**RE: Response to DEQ March 2, 2012 Letter, Willamette Cove Upland Facility
Residual Risk Assessment**

This letter was prepared in response to your letter to Dwight Leisle, Port of Portland on March 2, 2012 regarding the Residual Risk Assessment (RRA) for the Willamette Cove Upland Facility. The original DEQ comments from the March 2 letter are presented below, along with the Port's response, which includes subsequent discussions with DEQ. The responses below were prepared by Formation Environmental on behalf of the Port of Portland. We assume that these responses, combined with the attached tables and figures are sufficient for the Port to begin preparation of the RRA, and no other planning documents (e.g., work plans) are needed. The Port will also proceed with submittal of a revised work plan for sampling the former Wharf Road, as agreed to in the responses below.

FIGURE 4

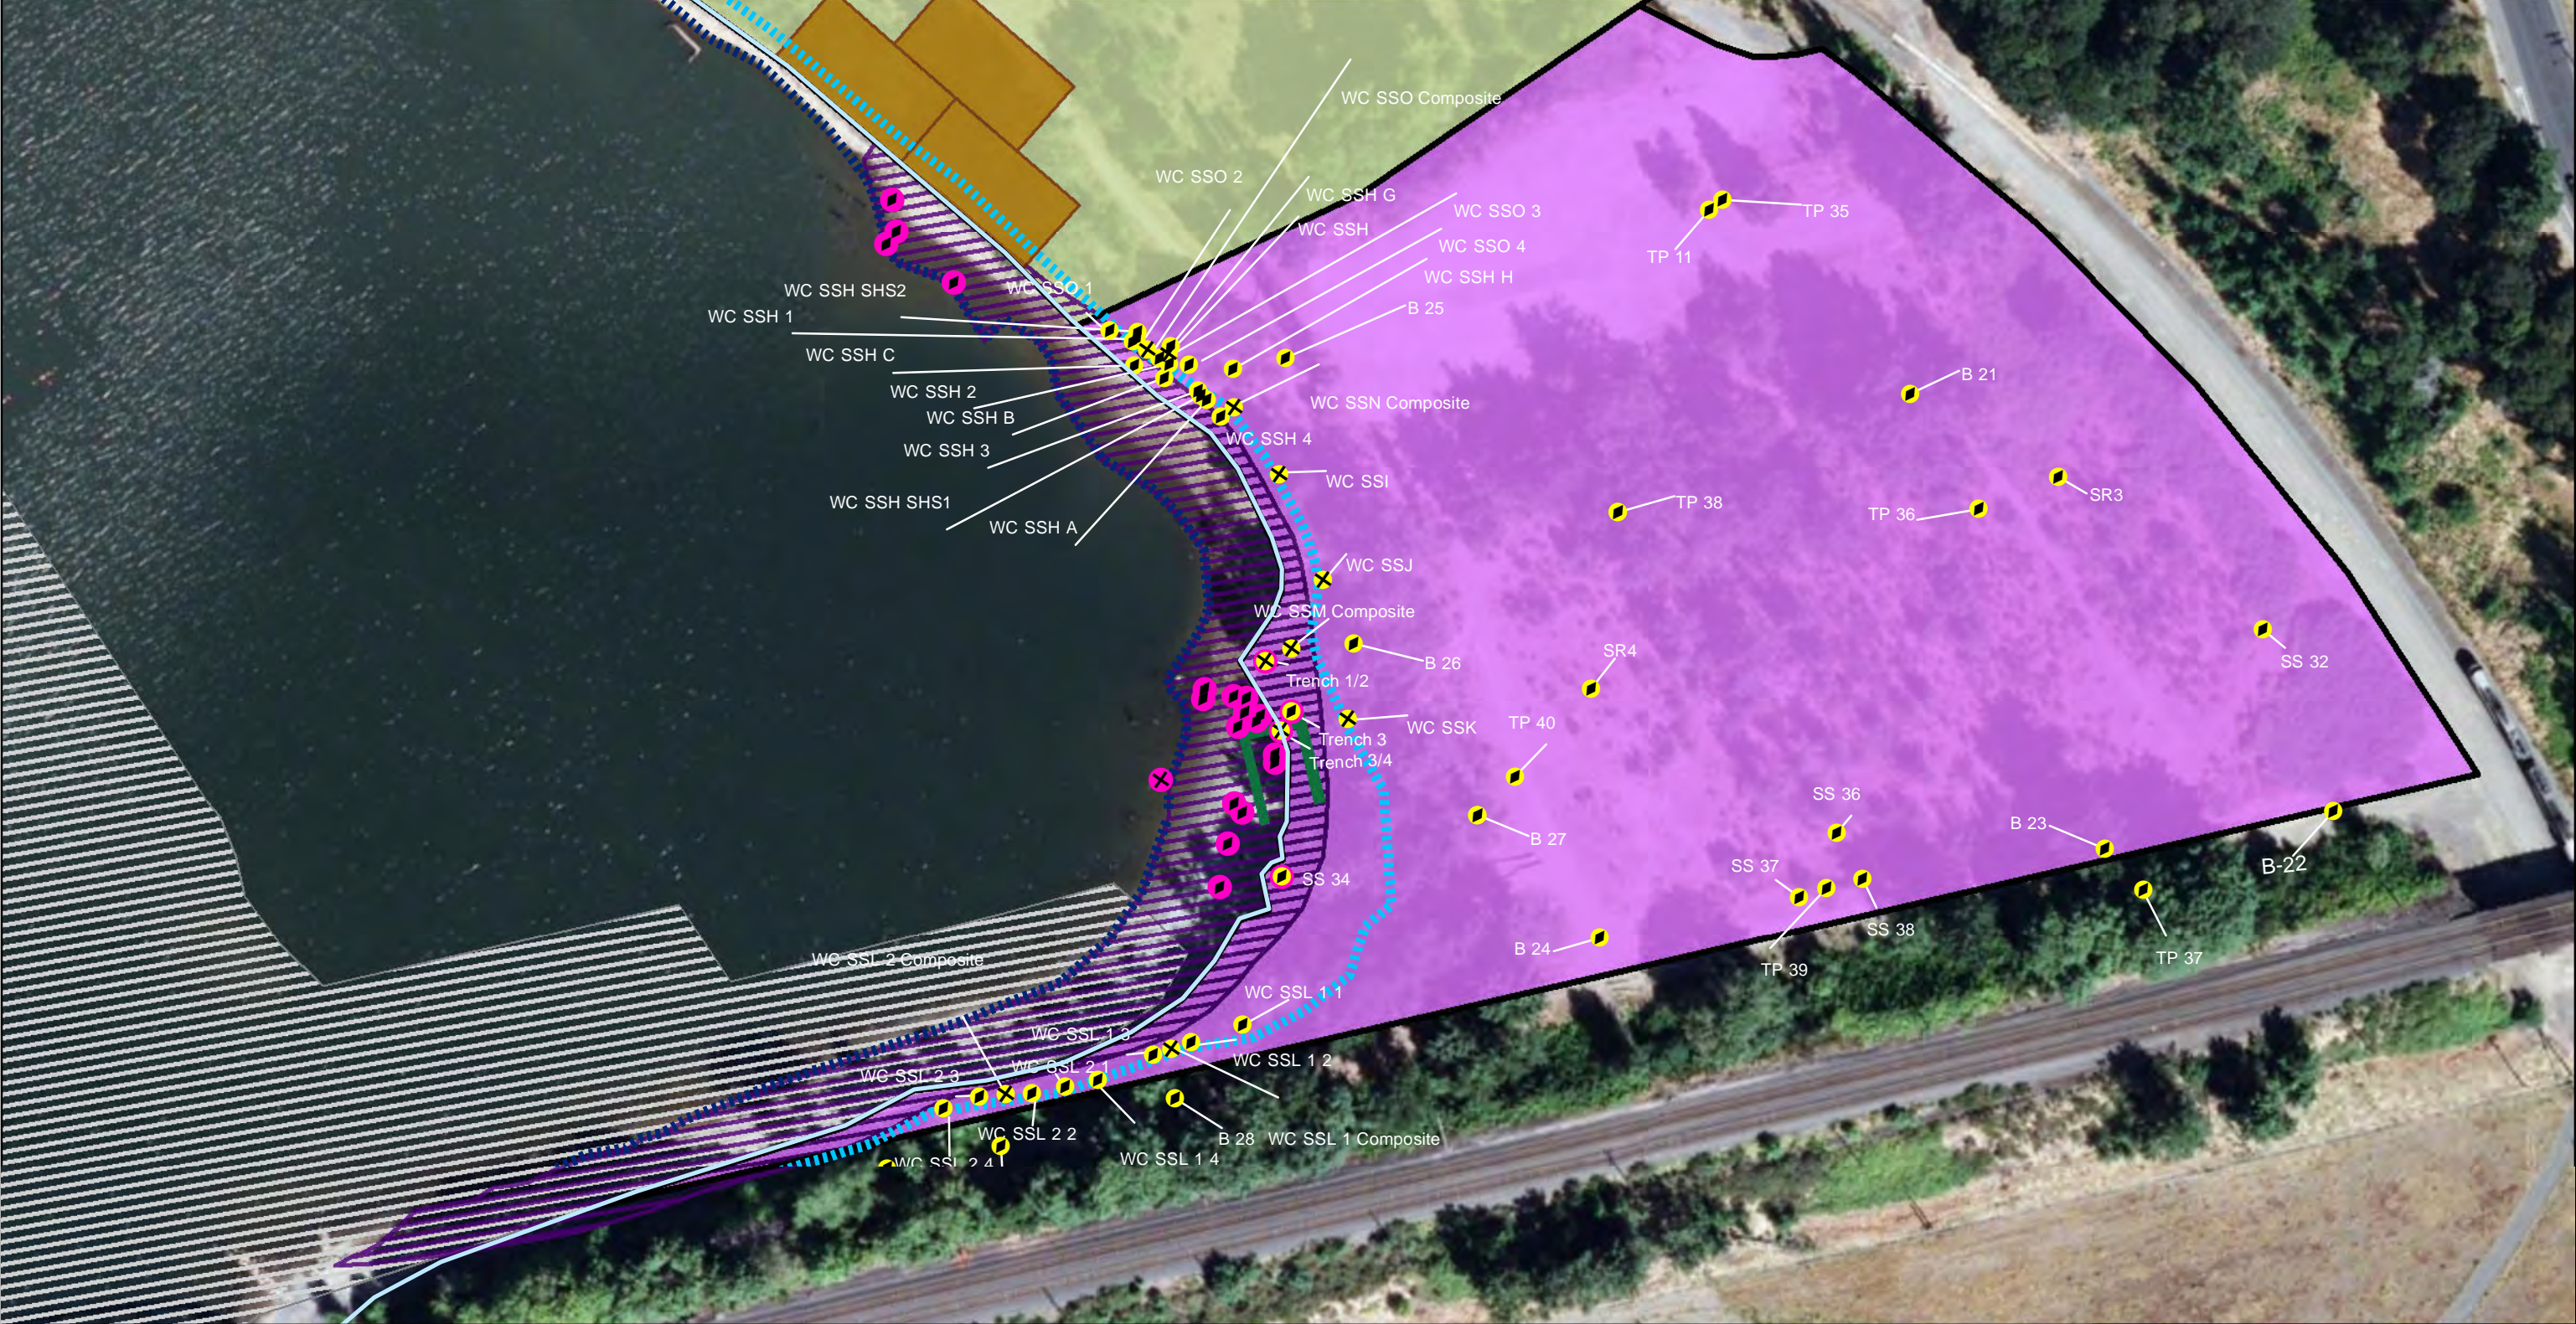
Note: An “in-water” data point is included on Figure 3 and Table 4 and is intended to represent the Central Beach Exposure Unit. This “in-water” location is labeled LW2-B015. Although this point plots “in the water” based on coordinates in the LWG database, this sample is a “Round 2a beach sediment composite” from 2004 and corresponds to the sampling area called “Beach Area B14”, which was specifically added to the RRA dataset at the request of DEQ in the letter dated Feb 2, 2012 (See also Comment #5 below.) .
